L-SB-0005-12

HID Headlamp Housing Paint Bubble / Poor Appearance

February 1, 2012

REVISION NOTICE

If a poor appearance is found, continue to step 2. If not, this bulletin does **NOT** apply. Figure 1.

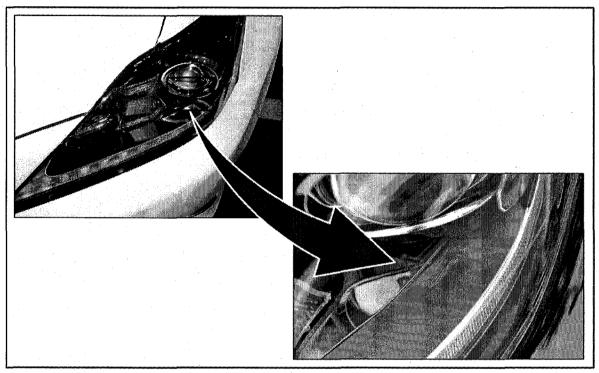
Some 2011 – 2013 model year IS 250/350/250C/350C and IS F vehicles equipped with HID (High Intensity Discharge) headlights may exhibit a paint bubbling/wrinkling condition on top of the LED strip within one or both of the headlight housings. Newly designed headlight units have been developed to address this condition. Follow the procedure in this bulletin to install the updated headlight units.

1. Confirm vehicle has the headlight housing paint bubble condition (see Figure 1 for an example).

- 2. Replace both headlight units.
 - A. Remove both headlights.
